Moving-Off Information Signal (MOIS) Regulation
Consensus Document for Proposed Updates to Draft
VRU-Proxi-13-12

February 2020

Max. Forward Detection Boundary (Q2)

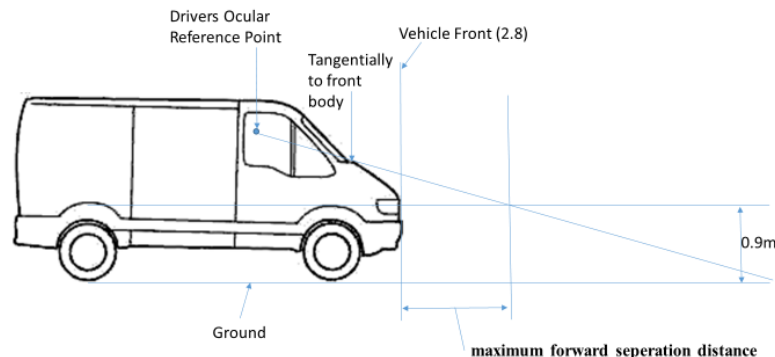
Shall the max. forward detection boundary depend on direct vision performance?

- OICA/CLEPA Proposed Update:
 - **Update definition of maximum detection boundary to be dependent on the maximum forward blind spot distance**
- Proposal Justification:

- The direct vision performance of the vehicle can be taken into consideration through Regulation
 - Allows differentiated approach between vehicle categories, e.g. M2/M3 vehicles have better direct vision than the majority of N3 vehicles, so shorter max. forward detection distance criteria

- Attempts to remove requirements to provide signal for VRUs that may be visible to driver
- Previous/Alternative Options:
 - Maintain requirements to test MOIS performance at a maximum forward detection distance of 3.7m

- Set two boundaries (3.7m and a shorter range (1.25 m?)) that apply to different vehicle categories
- Summary of VRU-Proxi-12 Decisions:
 - Effect of direct vision shall be considered in the requirements for different vehicle categories

- Worst-case direct vision blind spot distance from front end to be used to determine max. distance, with LDS calculating worst-case distance of 3.7 m

Forward blind spot boundary for M2 vehicle

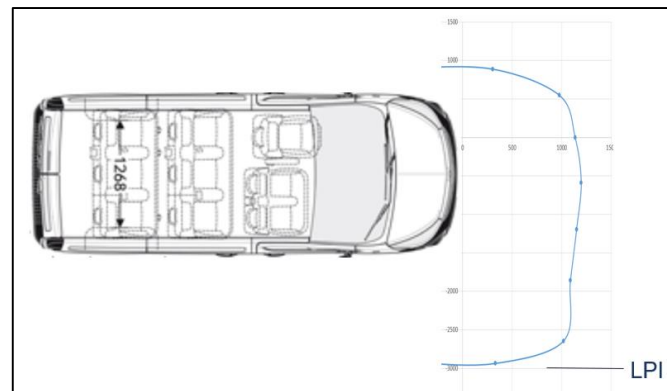
- OICA/CLEPA Proposal 2 Approach:
 - Max. forward detection boundary determined by:
 - Forming a plane (“max. forward detection boundary plane”?) parallel to vehicle front plane at furthest forward blind spot of the vehicle [*and within the boundaries of the maximum LPIs*]

- Blind spot determined by projecting sightlines from ocular reference point onto plane 0.9 m above ground
 - OR a distance of 3.7 m at the choice of the manufacturer

- [*BUT no less than 1.25 m for adult and 1.15 m for child (1.0 m clearance)*]
 - Approach challenges
 - Test method needs to be defined
 - Proposed to use light source at ORP and 0.9 m high pole to determine forward boundary of blind spot

- How to deal with obscurations – e.g. mirrors/wipers?
 - How to deal with cab height variation?
 - Flat fronted designs typically have A-pillar blind spots that extend away from the vehicle – so max. distances will be determined by A-pillars

- Bonneted designs will be determined by bonnet projection

Max. Forward Detection Boundary (Q2): Evidence #2a

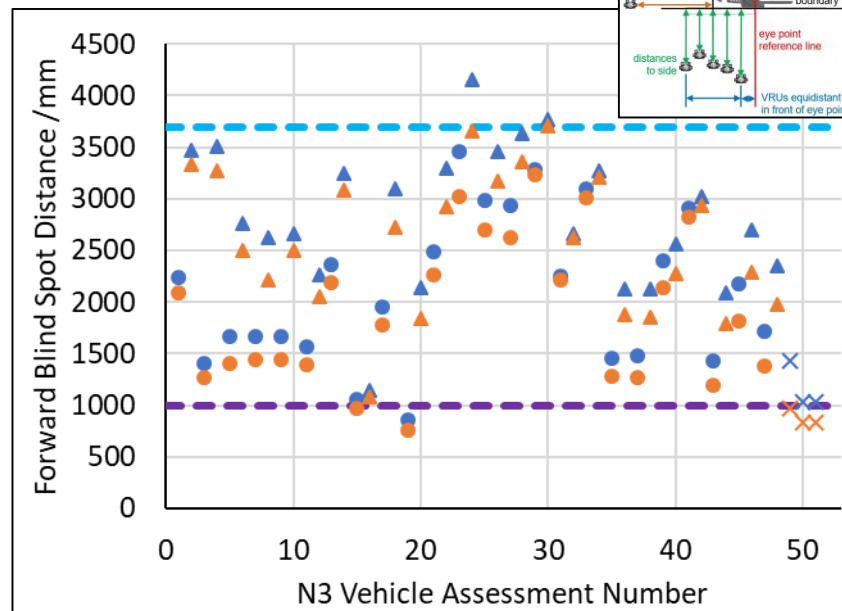
- Available Evidence Base:
 - Forward monocular blind spots for N3 vehicles
 - Legend:
 - Circles => Lowest cab height for given model
 - Triangles => Highest cab height for given model
 - Blue => Maximum forward blind spot distance
 - Orange => Mean forward blind spot distance
 - Assessment height => 1.117 m from ground
 - Conclusions:
 - N3 vehicles have a range of maximum forward blind spots – between ~0.9 m and ~4.2 m
 - N3 LECs have shortest max. forward blind spots
 - N2/M2/M3 vehicles likely to have similar forward blind spots to LECs
 - Some N3 vehicles have max. forward blind spots within range of ultrasonic sensors

Max. Forward Detection Boundary (Q2): Evidence #2c

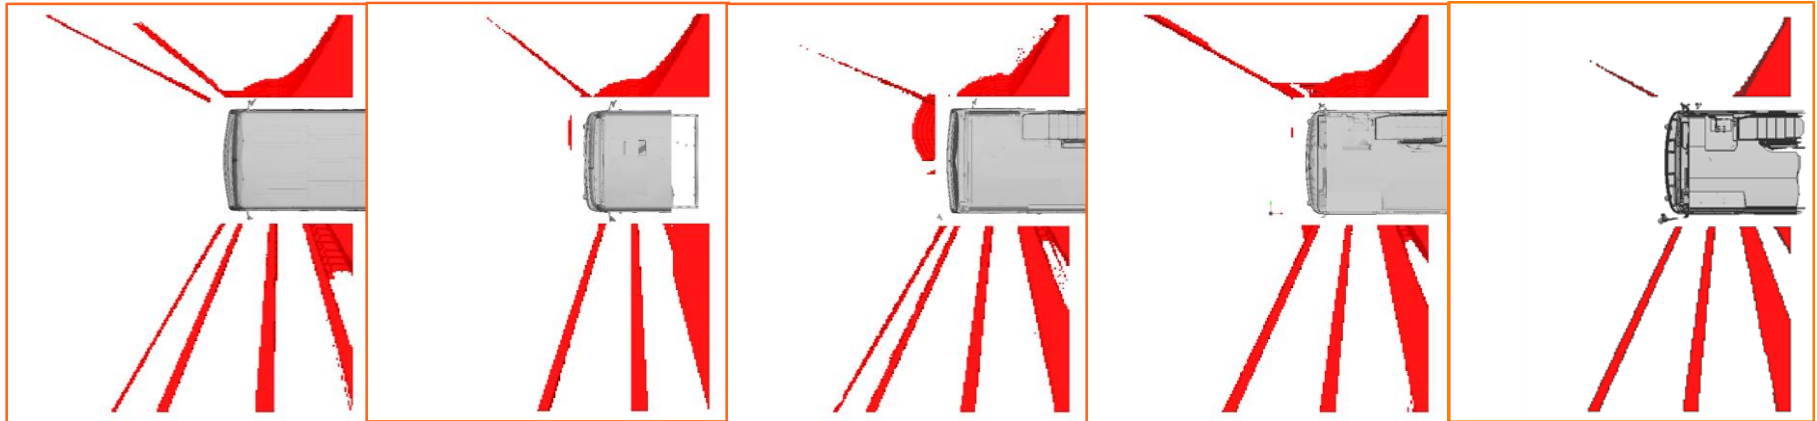
- Available Evidence Base:
 - Ambinocular direct vision blind spot zones for M3 vehicles
 - Blind spots above 1.117 m plane shown for 5 models (2 generations/2 decks) of London buses
 - Forward blind spots primarily caused by A-pillars – large glazed areas and low windscreen edge similar in design philosophy to Low-Entry Cabs

Min. Forward Detection Boundary (Q3)

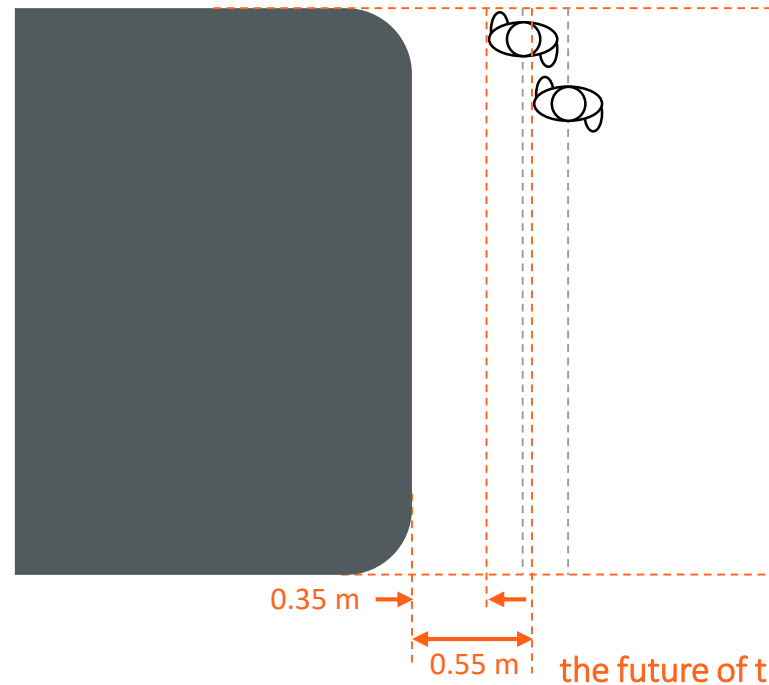
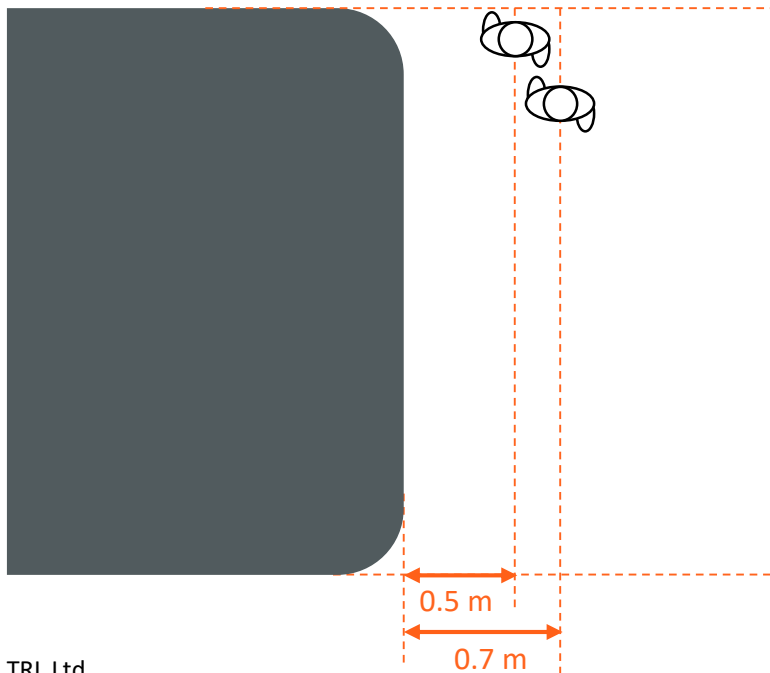
Shall the min. forward detection boundary be increased?

- OICA/CLEPA Proposed Update:
 - **Increase the minimum forward detection distance from 0.6m to 0.8m**
- Proposal Justification:
 - Challenging to use a single short-range radar sensor to detect distances <0.8m (0.55m separation)

- Min. forward detection distance of 0.6m (0.35m separation) more suitable for ultrasonic sensors, but these cannot sense to 3.7 m
- Previous/Alternative Options:

- Maintain minimum forward detection boundary requirement of 0.6m, but fusion of extra sensors will likely be needed for system (ultrasonic sensors on front of vehicle most likely approach)

- Have two separate min. detection distances based on max. distance (N2/M2/M3 likely to have much shorter max. detection distances based on direct vision approach)

Min. Forward Detection Boundary (Q3): Evidence #3b

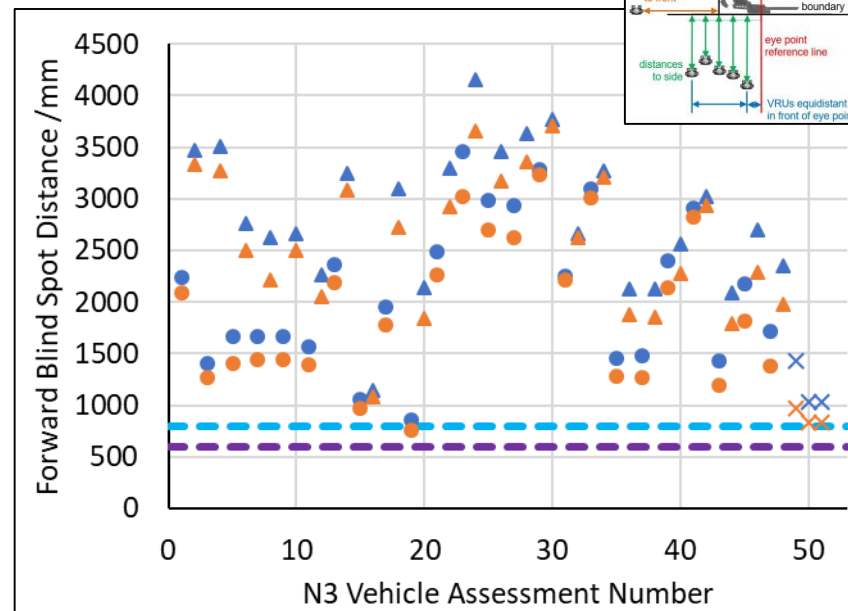
- Available Evidence Base:
 - Forward blind spot zones for N3 vehicles
 - Legend:
 - Circles => Lowest cab height for given model
 - Triangles => Highest cab height for given model
 - Blue => Maximum forward blind spot distance
 - Orange => Mean forward blind spot distance
 - Assessment height => 1.117 m from ground
 - Conclusions:
 - N3 vehicles with good direct vision (i.e. LEC) only required to fit MOIS with small forward detection area – as 0.8 m min. forward detection boundary is nearly met by ~1.0 m max. forward boundary
 - N2/M2/M3 vehicles likely to have similar forward blind spots to LECs
 - Case for 2 different min. detection distances based on max. detection distance criteria (e.g. 0.6 m when max. distance is 1.25 m)?

Offside LPI Boundary (Q4)

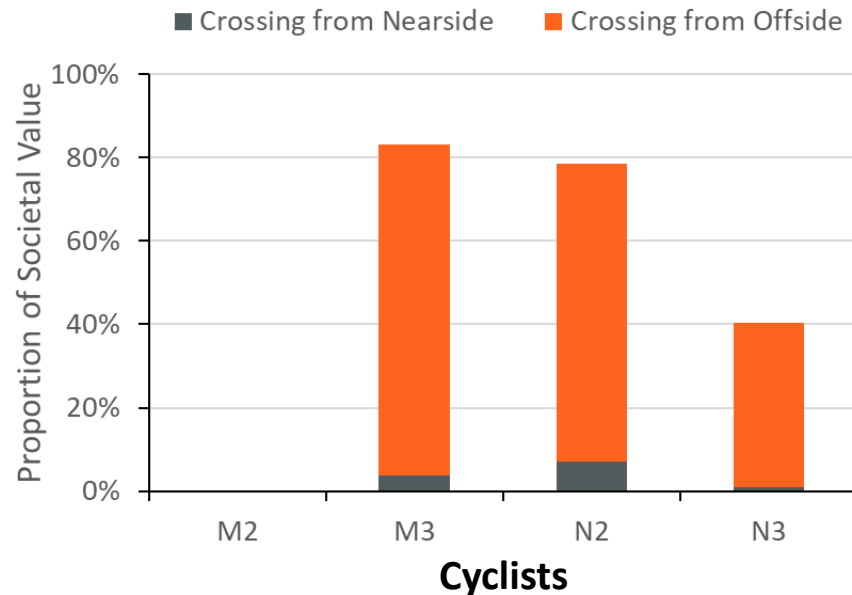
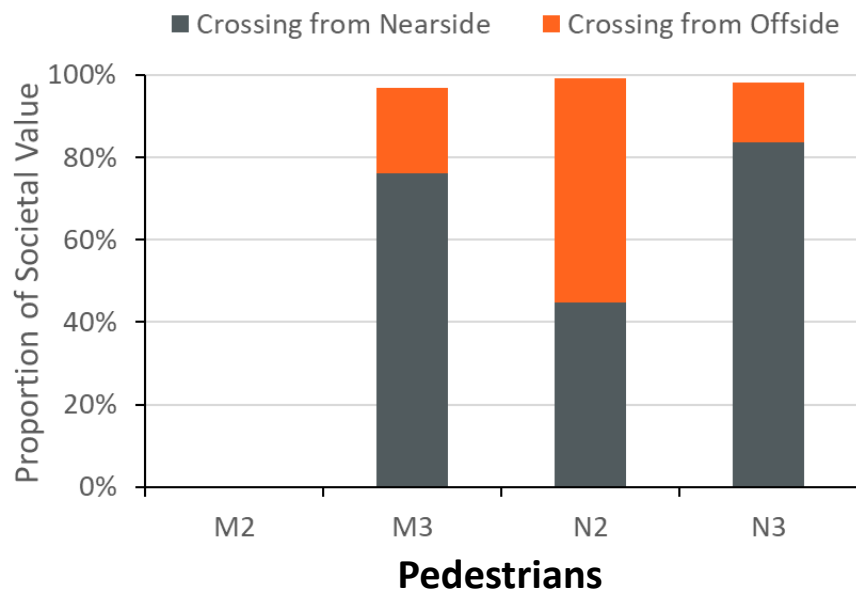
Shall the offside Last Point of Information (LPI) boundary be aligned with the offside plane?

- OICA/CLEPA Proposed Update:
 - **Modify the offside Last Point of Information requirements to align with the vehicle offside plane**
- Proposal Justification:

- Offside of vehicle has good direct vision therefore no requirement to provide information signal
 - VRU will have crossed a significant part of the carriageway already

- Previous/Alternative Options:
 - Maintain requirements to test MOIS performance at offside LPI based on VRU speed only
 - Modify offside LPI to be based on offside direct vision performance of vehicle

Offside LPI Boundary (Q4): Evidence #4b

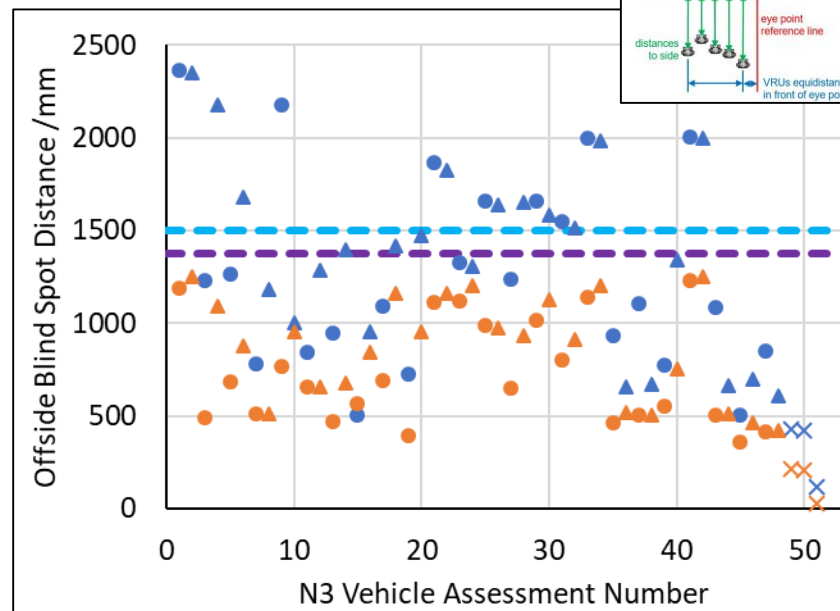
- Available Evidence Base:
 - Offside lateral blind spot zones for N3 vehicles
 - Legend:
 - Circles => Lowest cab height for given model
 - Triangles => Highest cab height for given model
 - Blue => Maximum forward blind spot distance
 - Orange => Mean forward blind spot distance
 - Assessment height => 1.117 m from ground
 - Conclusions:
 - Only four N3 vehicles have a max. offside blind spot of <0.5m (similar to earlier M2)
 - Most N3 vehicles have max. offside blind spot better than the worst-case LPI (5 kph)
 - However, significant number have a max. offside blind spot greater than worst-case LPI
 - LECs appear to have better offside visibility
 - Lowering same cab sometimes result in larger offside blind spot due to mirror cluster
 - Offside visibility likely to be affected by A-pillar and mirror cluster positioning

Nearside LPI Boundary (Q5)

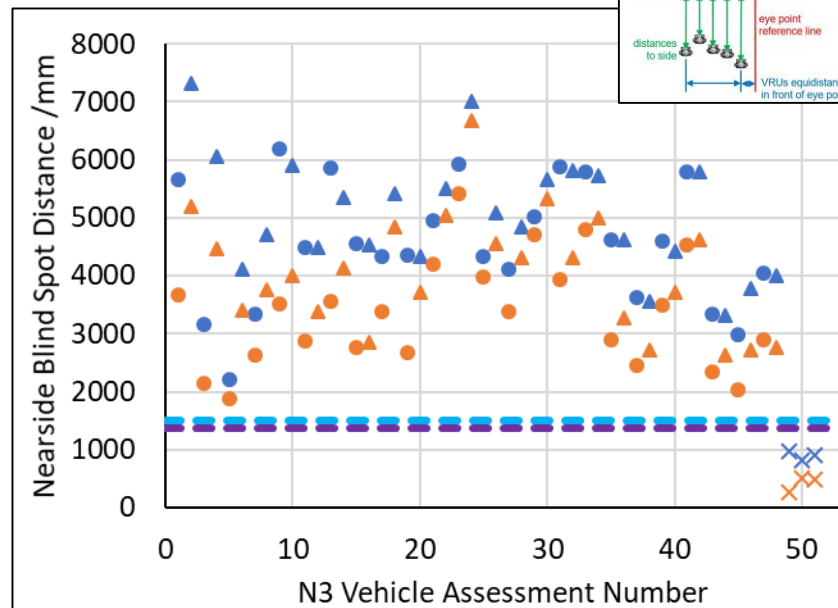
Shall the nearside Last Point of Information (LPI) boundary depend on direct vision?

- OICA/CLEPA Proposed Update:
 - **Update definition of nearside LPI to be dependent on the maximum nearside blind spot distance**
- Proposal Justification:

- Although most N3 vehicles do not perform well for nearside direct vision – N3 LECs and M2/M3/N2 vehicles may perform significantly better
 - Provides differentiated approach between vehicle categories based on direct vision capability
